Re: Turners Falls Hydroelectric Project (FERC No. 1889) and Northfield Mountain Pumped Storage Project (FERC No. 2485)  
Filing of November 17, 2014 Meeting Minutes re: Consultation on Studies employing Hydroacoustic and Telemetry Methods

## MEETING MINUTES

Re: Meeting to consult on studies employing hydroacoustic and telemetry methods.

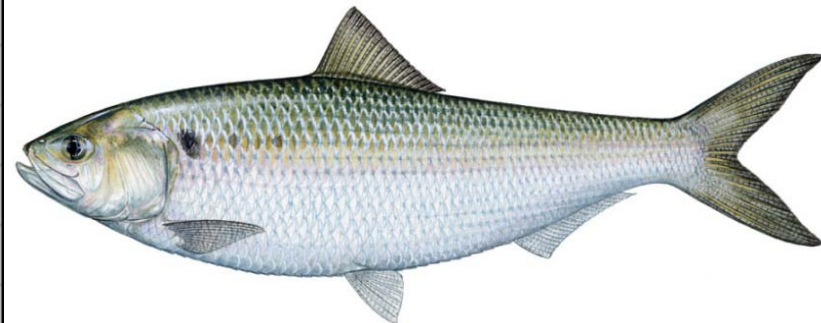
Chris Tomichek opened the discussion by presenting a slide describing the collection/tagging/release schedule (schedule) for adult American shad (shad). Caleb Slater was concerned that planned construction activities at the Holyoke Project may interfere with the collection of test shad. Chris Tomichek and Ken Sprankle replied that construction activities at Holyoke are anticipated to be conducted later in the year, after the shad collection period, and should not affect the study schedule. FirstLight will verify the time period for Holyoke construction.

Ken expressed concern that the shad schedule was proposed to begin early in the migration season (week of April 20<sup>th</sup>) and based on his analysis of shad passage at Holyoke suggested that the shad peak has traditionally occurred in the last two weeks of May. Caleb commented that the peak typically occurs during the third week of May. Ken asked the group for their thoughts about shifting the schedule to begin later in the season. Ted Castros-Santos agreed that the start of the schedule seemed early but commented that we need to be ready should shad become available. Ken stated that early migrants are typically males and they may be over represented in early test groups.

Don Pugh requested that some of the fish be tagged as late as the first week in June. The group agreed that this request was manageable and offered to move some of the tagging to the late May through the first week of June time period. This will be accomplished by tagging fewer individuals earlier in the season so that tags will be available for late migrants while conserving the total number of test fish overall. Ted commented that shad should be available into June.

Tom Sullivan requested (from the agencies) a proposed *shifted* schedule, the reason for the request and associated data.

- FL to verify time period for 2015 Holyoke construction.
- Agencies to propose a shifted schedule for the adult shad tagging dates.
- Agencies will provide a list of agency personnel (~2 people) to be designated to help the study team make real time decisions when deviation to the adult shad flow release schedule occurs.

**5,000 cfs**

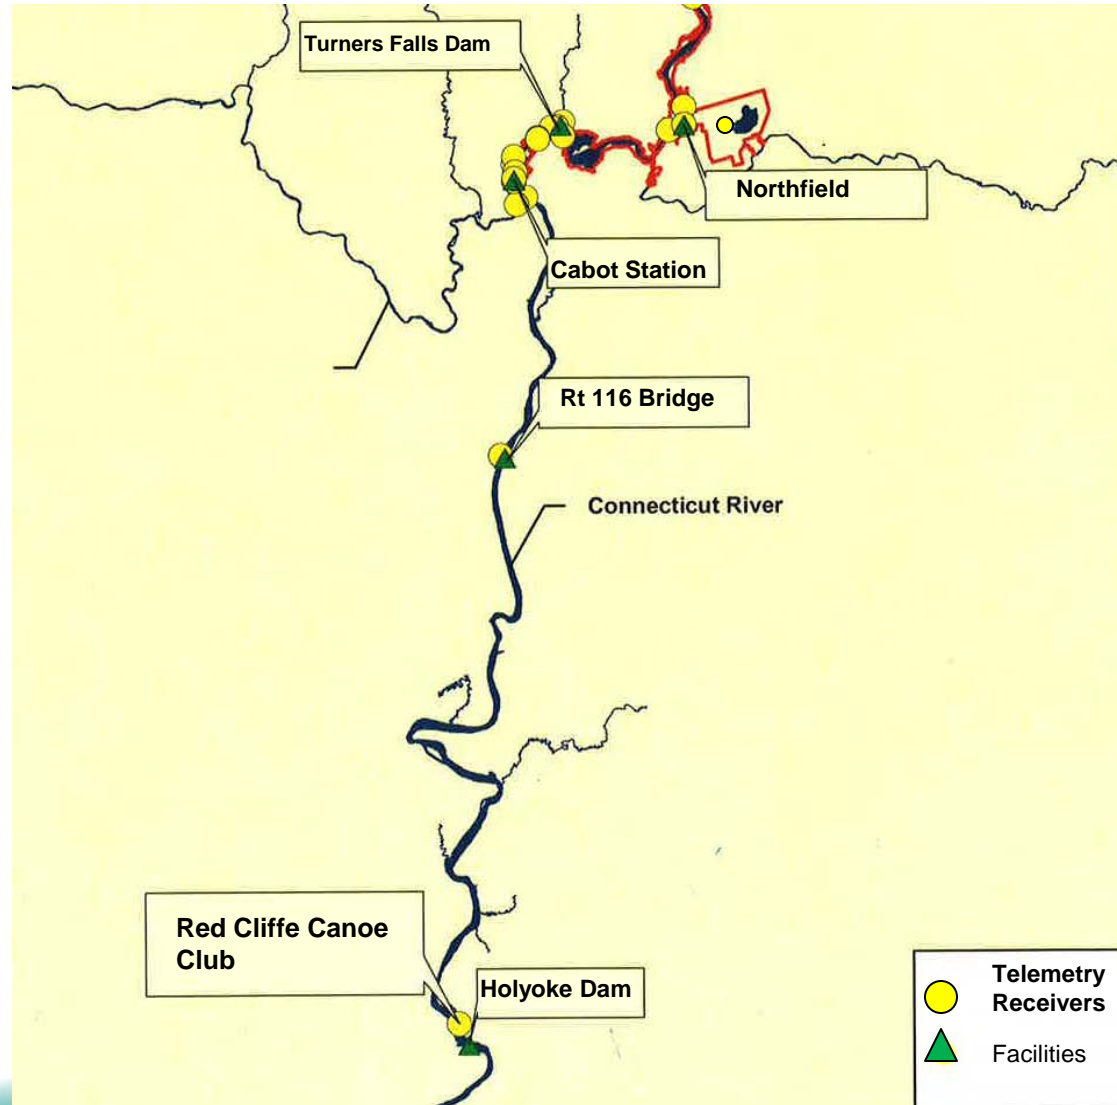
Chris Tomichek presented photos of Bascule Gate No. 1 and the spillway fishway entrance at three flows scenarios; 1,000, 2,500 and 5,000 cfs. Chris asked the group for their opinions on how release flows should be allocated to the bypass reach. John Warner expressed concerns that flow releases from Bascule Gate No. 1 may affect passage at the spillway ladder. Don Pugh suggested that some of the flow may be diverted to Bascule Gate No. 2 and commented that we need to make the spillway fishway entrance conducive to passage. Ted echoed the concern offering that the spill releases may help to get fish to the dam, but may not be conducive for passage, particularly at the high flow scenario and suggested that the flow should not exceed 1,000 cfs in the entrance area to be viable for passage. Melissa questioned the usefulness of testing high flow scenarios if they were greater than feasible for a long-term solution.

Tom questioned if some of the flow in the bypass could be provided by Station No.1. John Warner was concerned that flow from Station No.1 may confound the issue and induce delay. Melissa echoed this concern adding that it may be particularly problematic at lower flow scenarios when false attraction to Station No. 1 is more likely. John Warner agreed, but stated that it may be an option at the high flow scenario. John Howard commented that Station No. 1 is typically operated at capacity when active but that FL could operate it at a lower flow if necessary. The agencies will provide what data they have that relates flows and/or release locations to passage numbers to FL.

## Study 3.3.3 Downstream Passage of Juvenile Shad

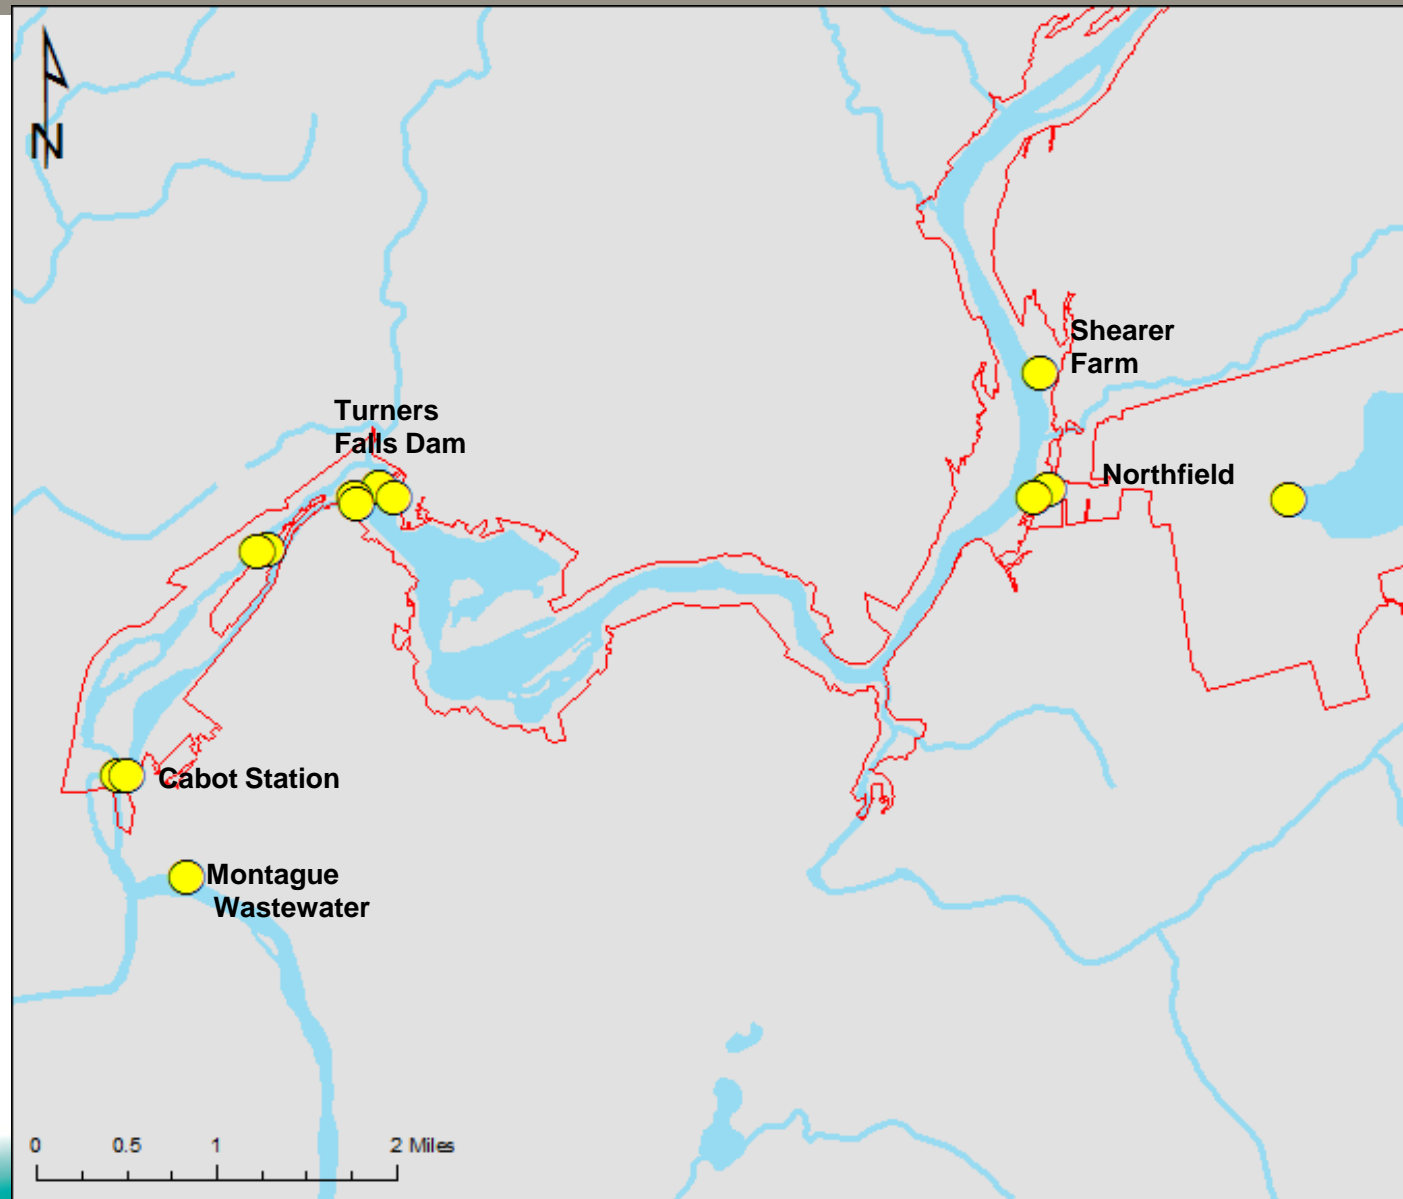
Chris opened the discussion by presenting slides describing the juvenile shad sample size release plan and monitoring locations. Ken asked if the gatehouse would be monitored using radio telemetry. Bryan relayed that a monitoring location would be employed downstream of gatehouse in the canal as specified in the RSP. Ken recommended telemetry coverage at the gatehouse to evaluate delay at the gatehouse and at the bascule gate. FL agreed to evaluate the request.

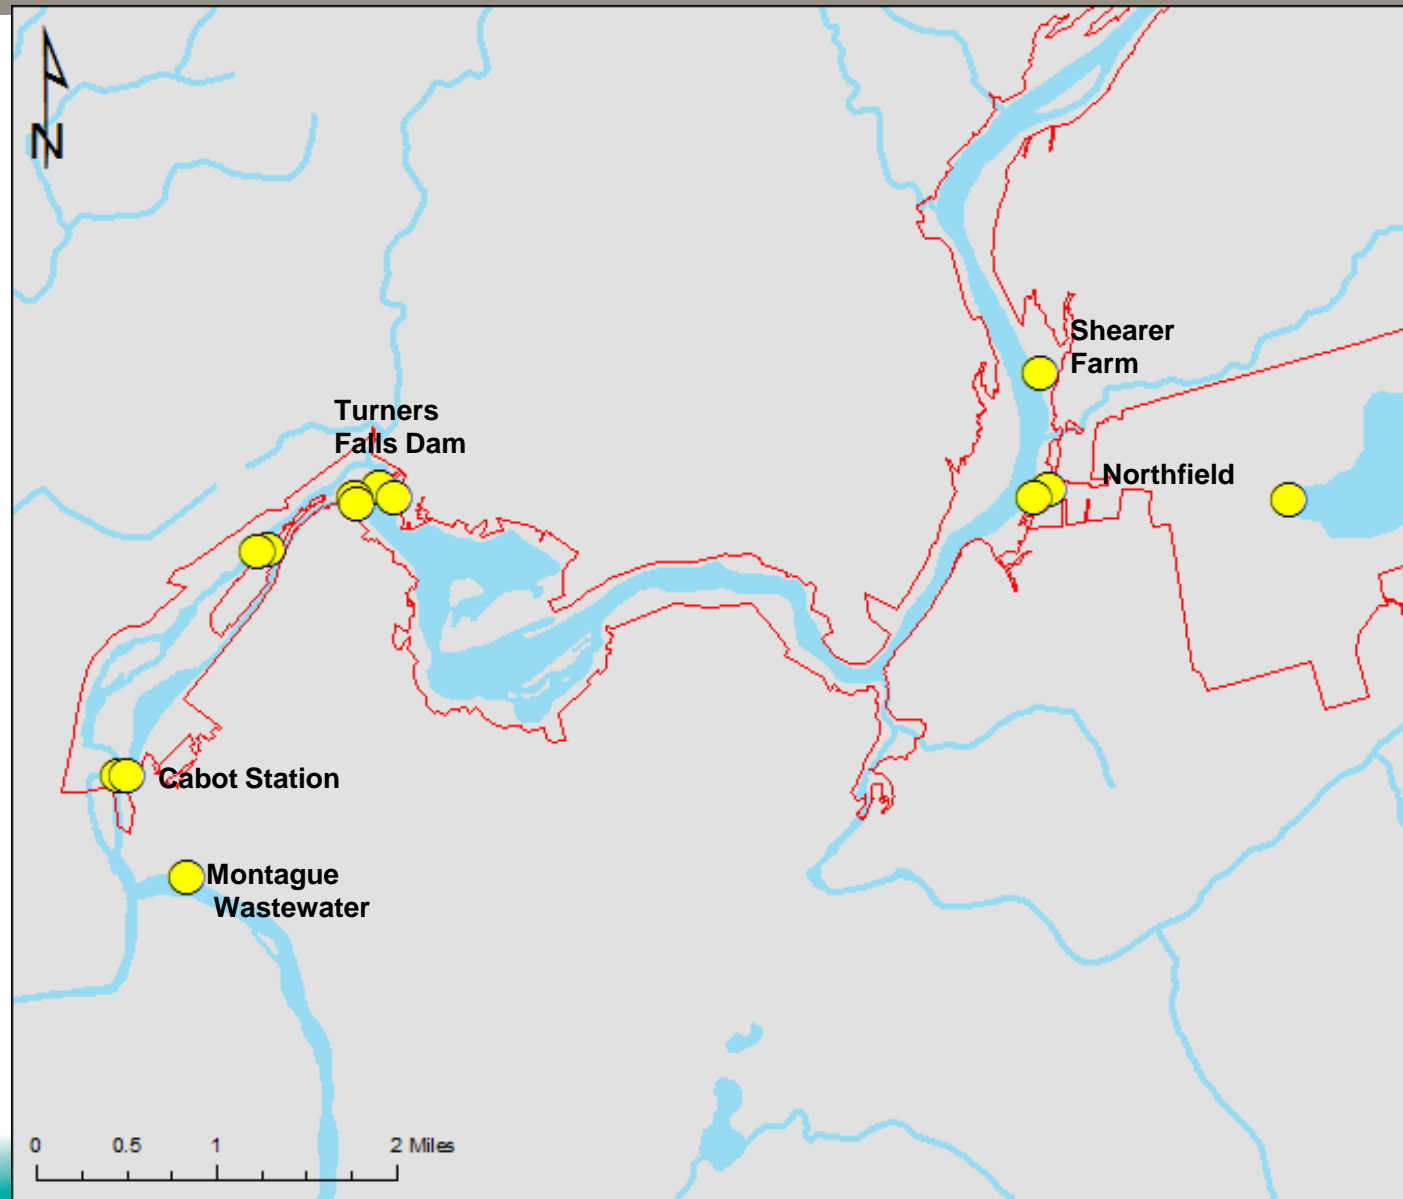
Chris began the discussion by presenting a slide describing the American eel release schedule at Northfield and Turners Falls. Alex asked where the test eels would be collected. Chris replied the Holyoke sampler. Alex commented that the USGS had collected eels at this location for use in studies and commented that there is no evidence of *learning* by eels. He went on to caution that collection may be difficult, but on good nights, they have collected ~14/hr and recommended collecting information on each test eel including source, length, weight and eye diameter.

Chris agreed and expressed concern about getting enough eels and asked if importation of eels from outside the basin would be acceptable. Caleb agreed to consider the idea and requested information from the study team about similar importation efforts. Bryan commented that Kleinschmidt was able to import eel into New York and agreed to share the information with Caleb. Alex commented that he had seen no evidence of behavioral changes from imported eels and agreed that it would be an option for the study.

Alex commented that the detection zone in the impoundment may need dropper antennas to detect eel in the deeper areas and suggested testing. Bryan commented that preliminary testing had been done to a depth of 5 ft but agreed that deepwater antennas would likely be needed for eel. FL agreed to consider the use of deepwater antennas and alternative receiver locations near the gatehouse to investigate the proportion of fish entering the canal vs. those bypassed through spill at the dam.

Ken and Don Pugh expressed concerns about not having a monitoring zone further down river than was proposed in the RSP. Don Pugh suggested that a monitoring station at the Rt. 116 Bridge would help to inform on passage mortality at the dam. The FL study team agreed to look at monitoring this location.

- FL to supply stakeholders map demonstrating radio telemetry detection zones for downstream eel and juvenile shad studies.
- FL to investigate an additional radio telemetry receiver at the RT. 116 Bridge for the downstream eel and juvenile shad studies.
